**Project No. V025-13807**
**ADDENDUM NO. 3**
**Rawson Avenue Storm Water Lift Station**
**700 West Rawson Avenue, Oak Creek, WI**

**Project No.: V025-13807**
**Date of Addendum: 10/2/13**

This Addendum to the Contract Documents is issued to modify, explain, or correct the original documents, dated 9/13/13, and is hereby made part of the Contract Documents. Acknowledge receipt of this Addendum in the space provided on the Bid Form, or bid may be rejected.

**STORM WATER LIFT STATION MCC ELECTRICAL ONE LINE DIAGRAM**

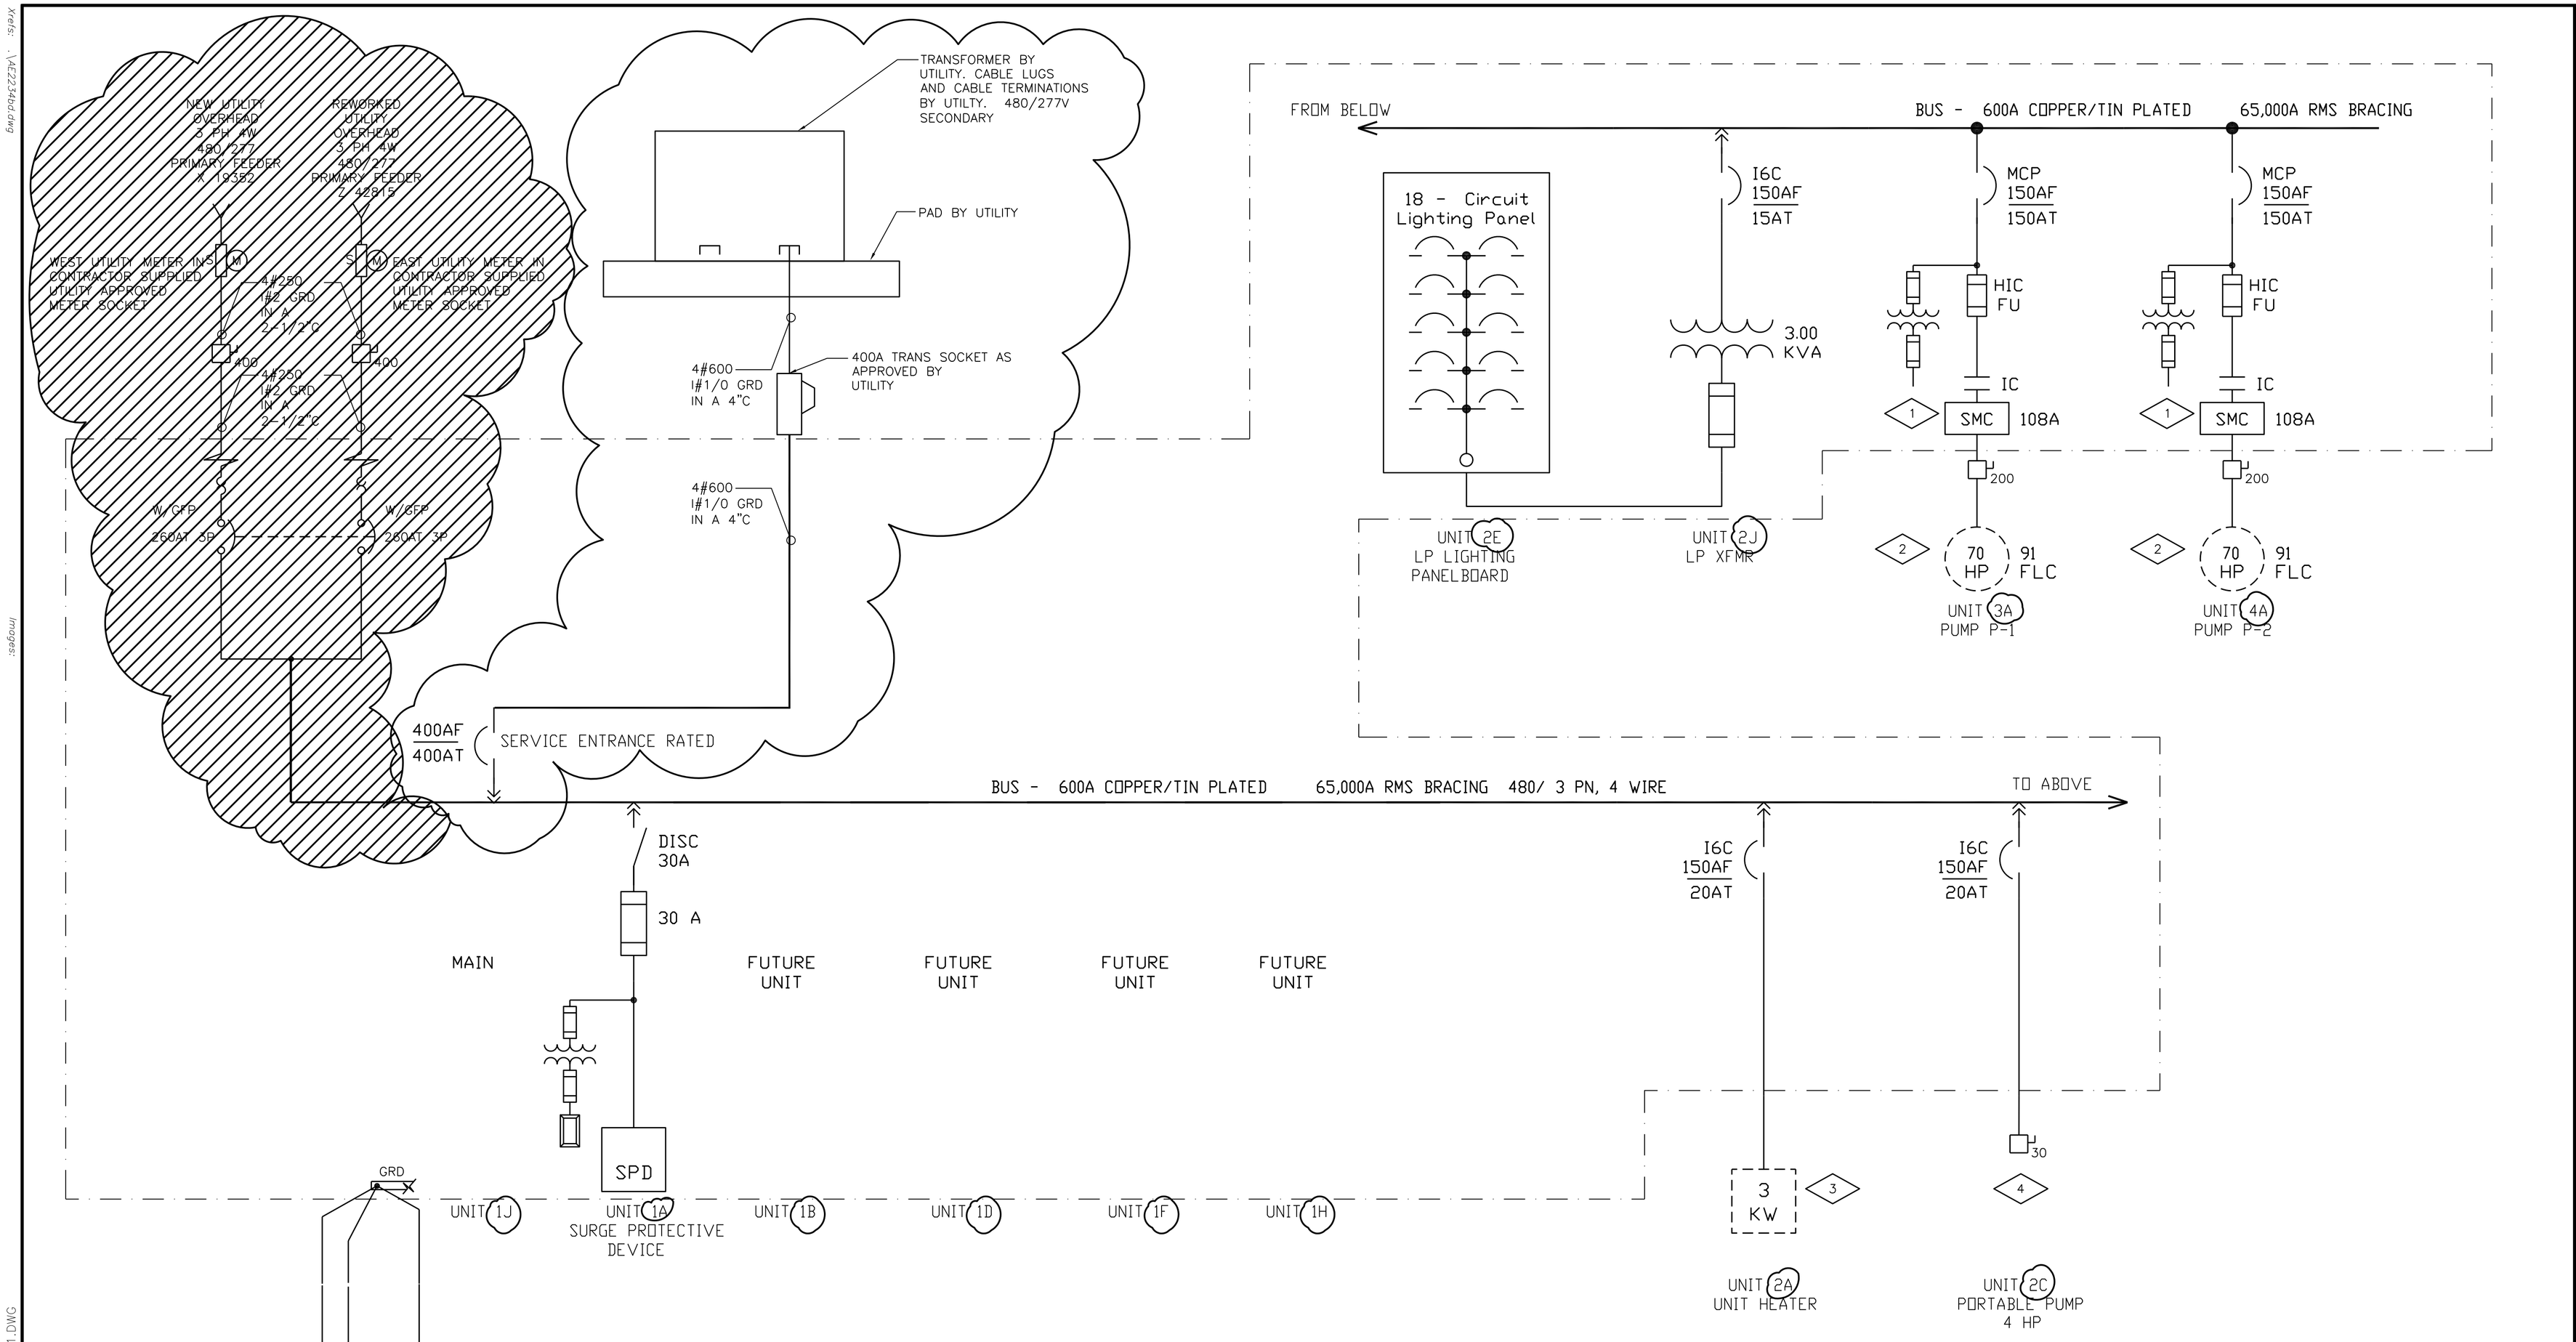
One utility overhead feed, meter, 400-amp disconnect, and portion of automatic transfer switch are to be deleted. Other utility feed to be marked as underground to utility provided pad-mounted transformer, meter socket to be marked 400-amp trans socket, 400-amp disconnect removed, breaker to be changed to 400-amp trip MCC main. 4#250, 1#2 GRD in 2-1/2-in.C to be 4#600, 1#1/0 GRD, in a 4-in. C.

## UNDERGROUND CONDUIT DETAIL (10-262)

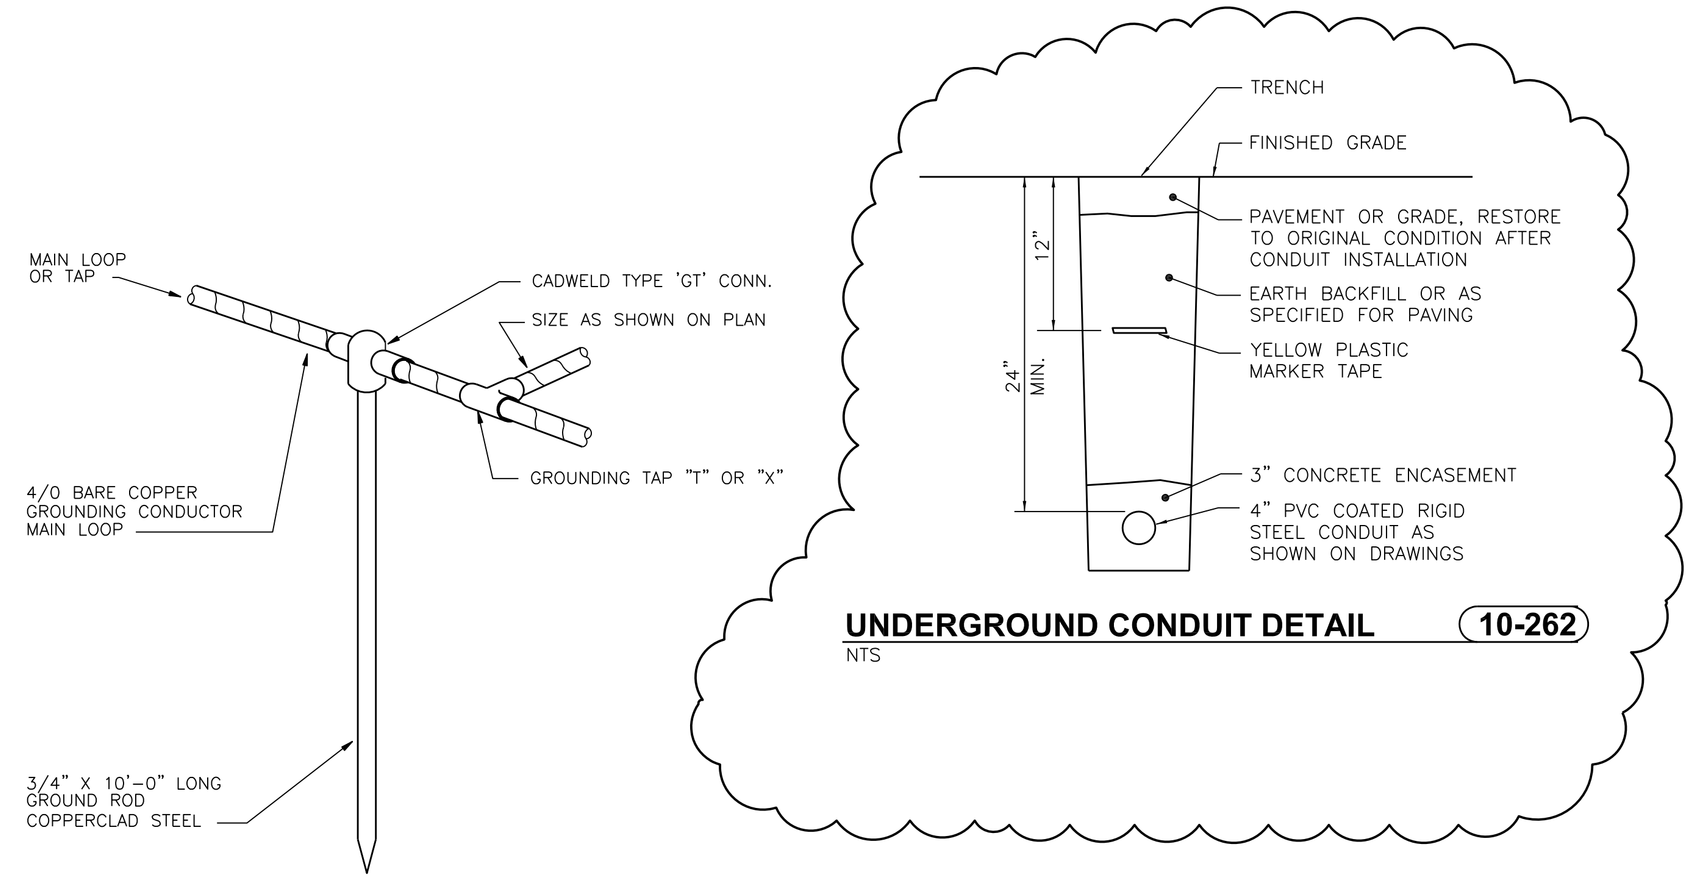
Add detail 10-262.

2. Inclusion of new MCC 400-amp trip main incoming circuit breaker compartment, 4#600 kcmil, 1#1/0 ground conductors (copper) in 4-in. conduit to contractor supplied We Energies approved 400-amp trans socket, 4-in. concrete encased underground conduit (refer to included detail 10-262) containing 4#600 kcmil, 1#1/0 to We Energies furnished and installed pad for We Energies furnished and installed pad-mounted transformer (refer to included detail 10-271).
